## STAFF RECOMMENDATION 2805 Blakemore Avenue October 16, 2013

**Application:** Demolition—primary building; New construction – infill and outbuilding  
**District:** Hillsboro-West End Neighborhood Conservation Zoning Overlay  
**Council District:** 18  
**Map and Parcel Number:** 10407009500  
**Applicant:** Randy Robinson  
**Project Lead:** Melissa Baldock, melissa.baldock@nashville.gov

<p><b>Description of Project:</b> Applicant proposes to demolish the existing structure, and construct infill and an outbuilding.</p> <p><b>Recommendation Summary:</b> Staff recommends approval with the condition that staff provide final review of windows, doors, brick sample, location of HVAC, and roof color. Staff finds that the project meets section II.B. and III.B.2. of the design guidelines for new construction in the Hillsboro-West End Neighborhood Conservation Zoning Overlay.</p>	<p><b>Attachments</b> <b>A:</b> Photographs <b>B:</b> Site Plan <b>C:</b> Elevations</p>
---	--

Sheet: A3.01

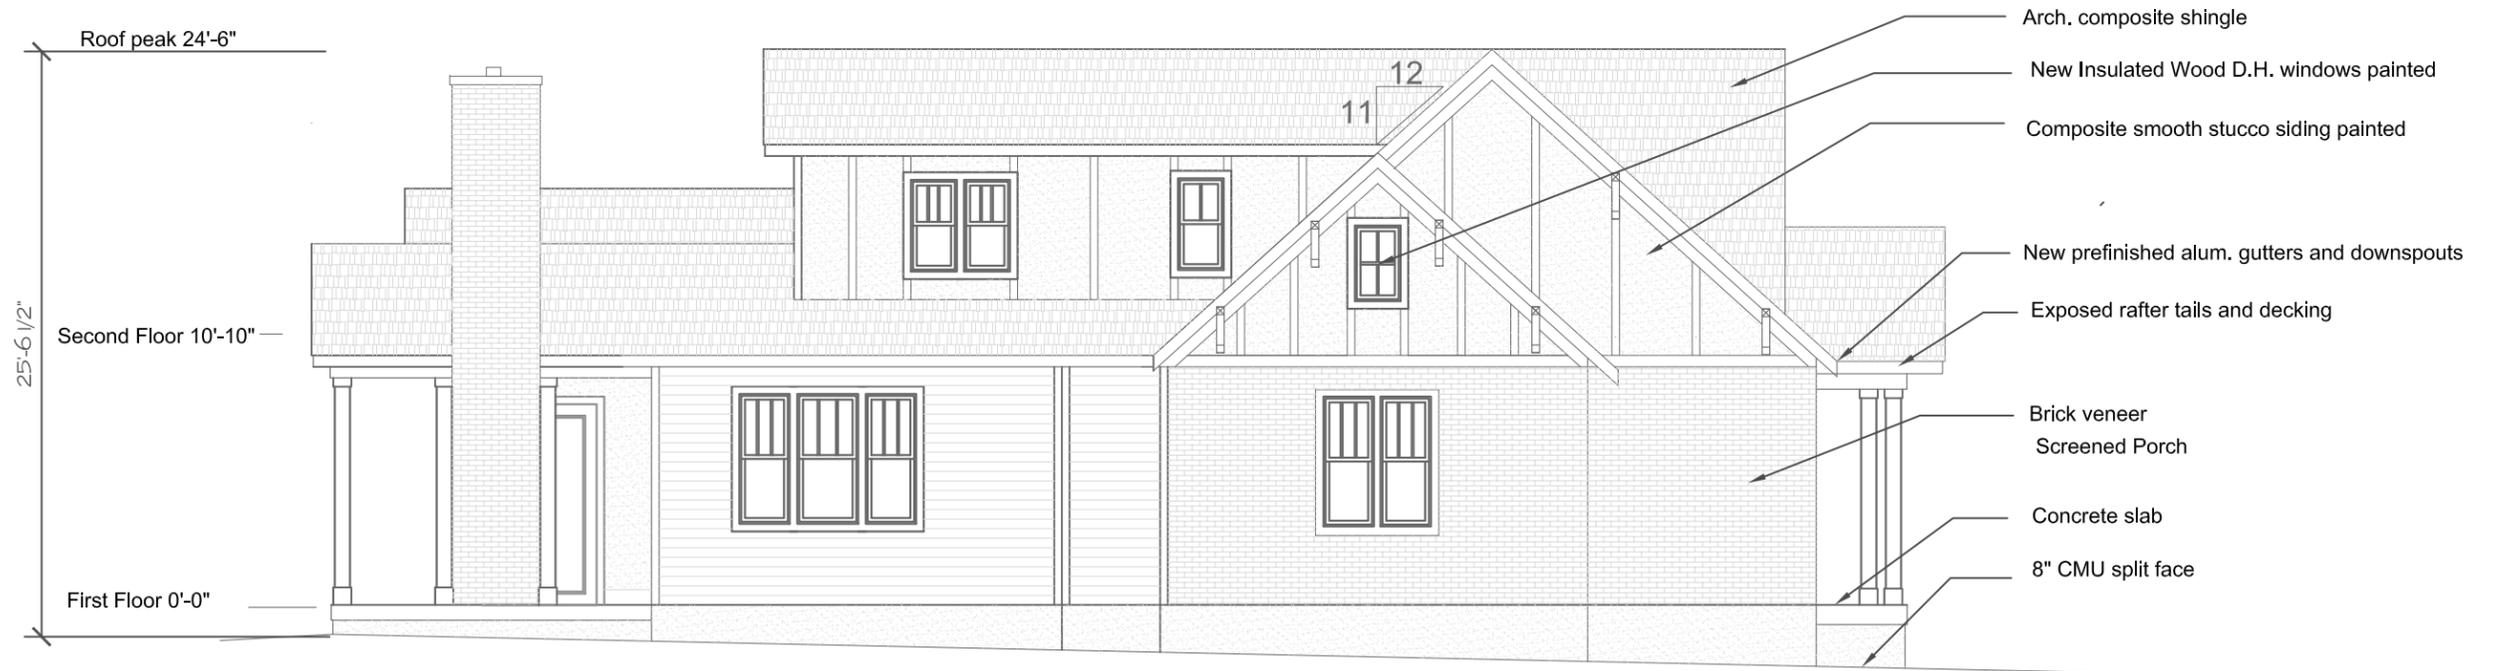
**Roof Shape:** The primary roof form is a side gable with an 11/12 pitch. The front porch has a gable with a 7/12 pitch. A central front dormer also has a 7/12 gabled roof form. The right slope of the gable merges with the right slope of the front porch. While not typically seen, staff finds that the combined dormer and porch roof forms meet the design guidelines. Staff finds that the project meets section II.B.e of the *Hillsboro-West End Neighborhood Conservation Zoning Overlay: Handbook and Design Guidelines*.

**Orientation:** The new home will be oriented towards Blakemore Avenue. Its partial-width porch is primarily thirteen feet (13') deep. Approximately two feet, six inches (2'6") of the porch will only be four feet (4') deep. The design guidelines state that infill construction should have a porch with a minimum depth of six feet (6'). Staff finds the reduced width appropriate in this instance since the majority of the porch will be thirteen feet (13') deep. The site does not abut the alley, so primary vehicular access will be from an existing curb cut and driveway (Figure 2). Staff finds that the house's orientation is appropriate for the neighborhood and meets section II.B.f of the *Hillsboro-West End Neighborhood Conservation Zoning Overlay: Handbook and Design Guidelines*.

**Proportion and Rhythm of Openings:** The majority of windows are twice as tall as they are wide, meeting the ratio of historic windows. The rhythm also meets the historic context as there are no large expanses without an opening. The project meets section II.B.g of the *Hillsboro-West End Neighborhood Conservation Zoning Overlay: Handbook and Design Guidelines*.

**Recommendation Summary:** Staff recommends approval with the condition that staff provide final review of windows, doors, brick, location of HVAC, and roof color. Staff finds that the project meets section II.B. and III.B.2. of the design guidelines for new construction in the Hillsboro-West End Neighborhood Conservation Zoning Overlay.

Sheet: **A7.01**

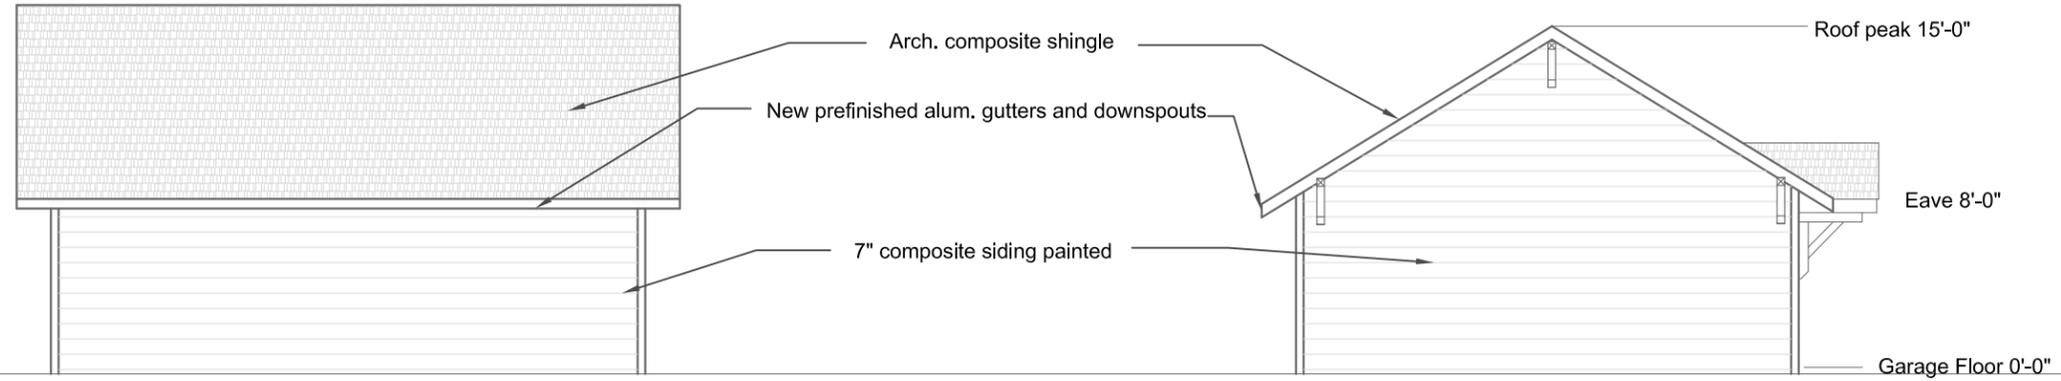
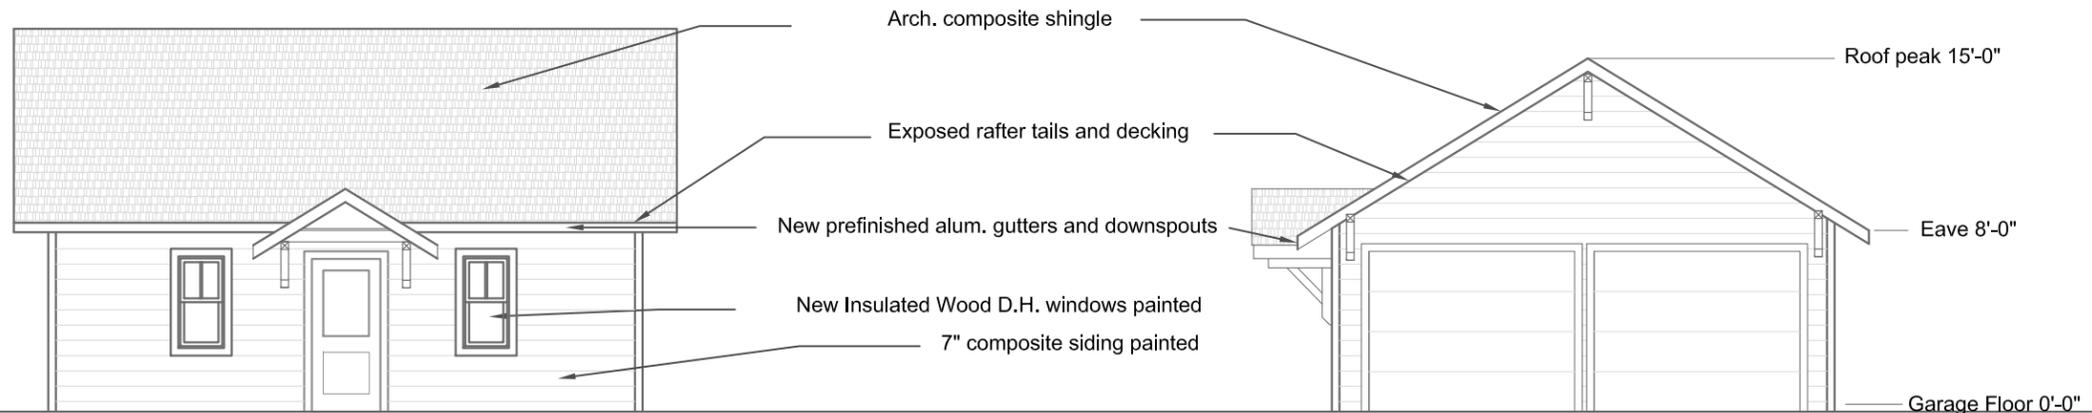
**Outbuilding:** The project includes a one-story garage that is twenty-two by twenty-six feet (22'X26'), or five hundred and seventy-two square feet (572 sq. ft.). The garage meets all base zoning setbacks, and will have garage doors that face the interior of the lot. The garage will be accessed via an existing driveway which will be extended to the rear

of the property. The garage will have an eave height of eight feet (8') and a ridge height of fifteen feet (15'), which is appropriate. The roof will be gabled with a slope of approximately 7/12. The proportion and rhythm of openings are appropriate for an outbuilding. Staff finds that the proposed outbuilding meets Section II.B.h.
